**SEAS DEADLINE 6 RESPONSE to APPLICANTS's SUBMISSIONS**  
**SINCE DEADLINE 5, ISH3, Action Points and ExQ3**  
**LANDSCAPE & VISUAL and CULTURAL HERITAGE**

**PINS Ref:** EN020026  
**DEADLINE 6:** APRIL 13, 2026

# EN020026 SEA LINK DCO – DL6: RESPONSE BY NICHOLAS BRIDGES

## ZTV ANALYSIS – IP ref FA62B0DA

**Figure 6. Sea Link 2023-10 PEIR Volume 3 Part 2 Chapter 2 Figures A, page 8:**  
 REPRESENTATIVE VIEWPOINT LOCATIONS AND SCREENED ZONE OF THEORETICAL VISIBILITY - PROPOSED SAXMUNDHAM CONVERTER STATION AND SPR FRISTON SUBSTATION (OPTION 1)

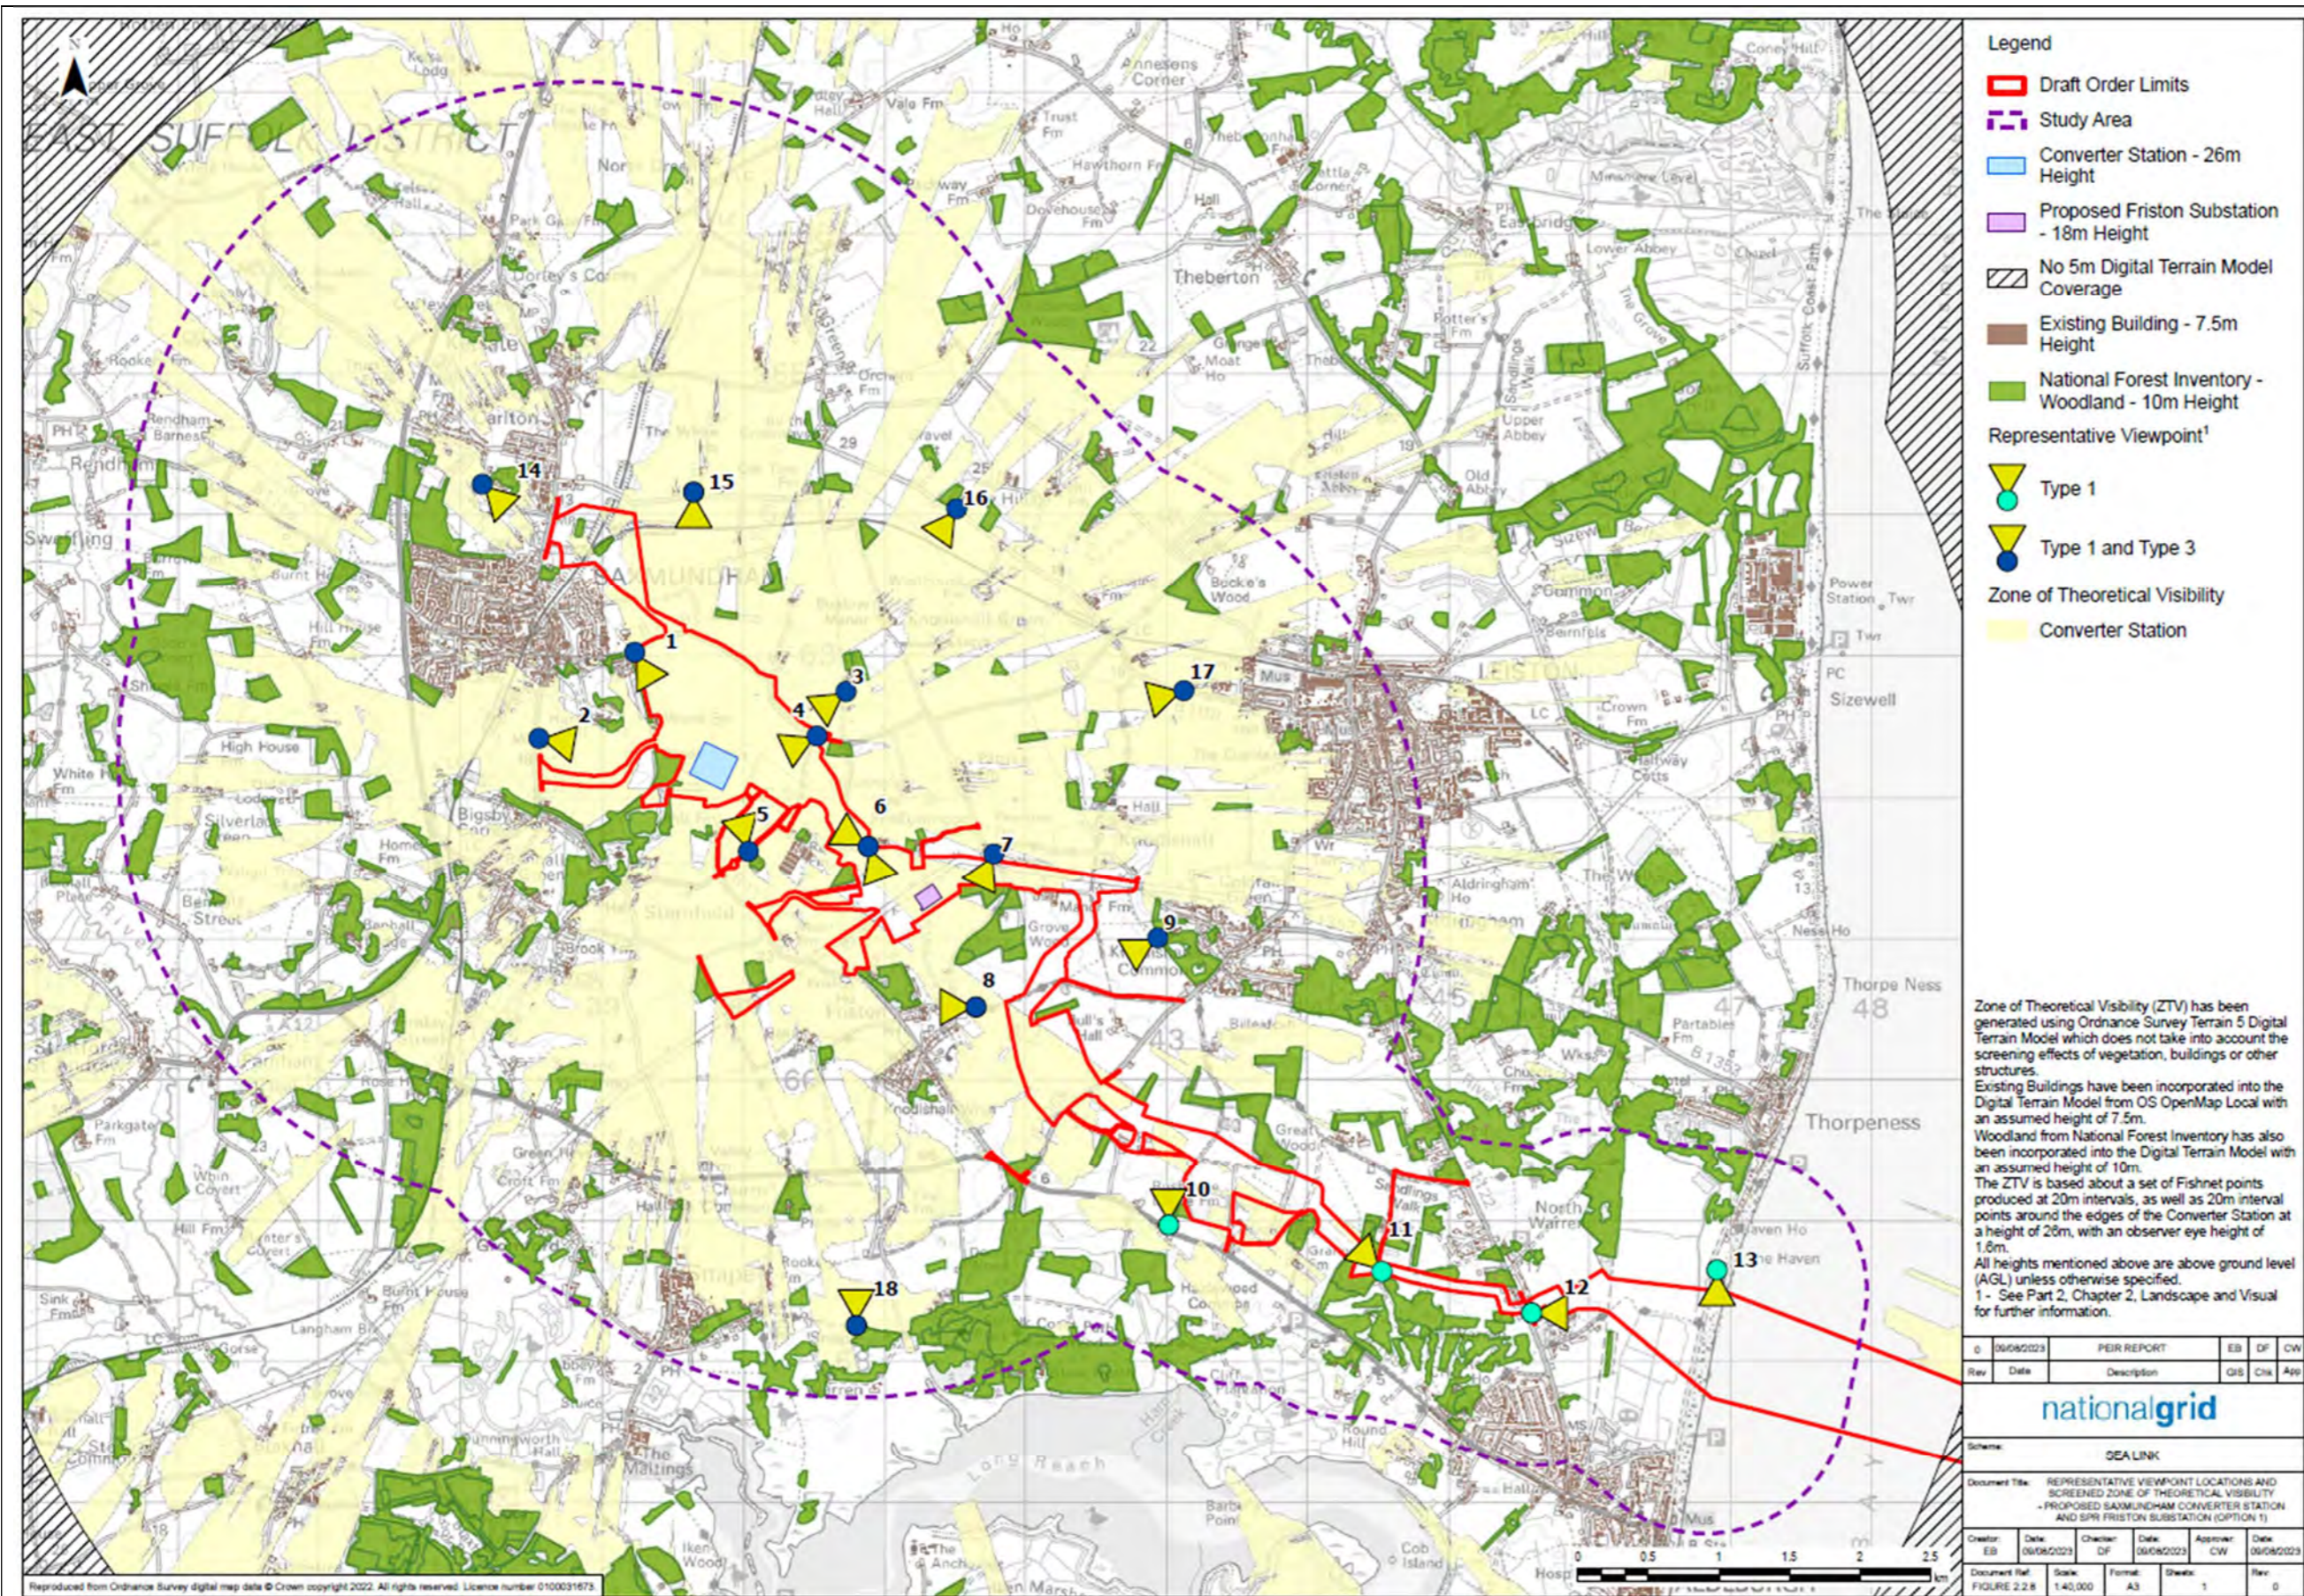
2.9. The ZTVs of the two Friston projects and Sea Link's PEIR have a similar pattern of visibility around their projects (see **Figures 1 to 11** below). Sea Link includes the National Grid substation at Friston which each of EA1N and EA2 also included. All Projects were modelled using OS contours, woodland and buildings at a generic height. Observer heights were a little higher for EA1N and EA2. The two Friston substations used the same parameter model as Sea Link.

2.11. The **first question** is: why are the PEIR and DCO plans so completely different? Were the heights in the model changed? Were the shadowing criteria altered? Which is correct? If the DCO is correct, were the EA1N and EA2 ZTVs incorrect? These are simple technical points which can be explained easily.

2.12. The **second question** is: With the majority of the ZTV plans showing extensive visibility of both Friston substations (18m above ground level) and Sea Link (26m above ground level) on the south side of the Alde estuary, at high tide mark and on the 20m ridge above, why was the information on these plans not followed or commented upon?
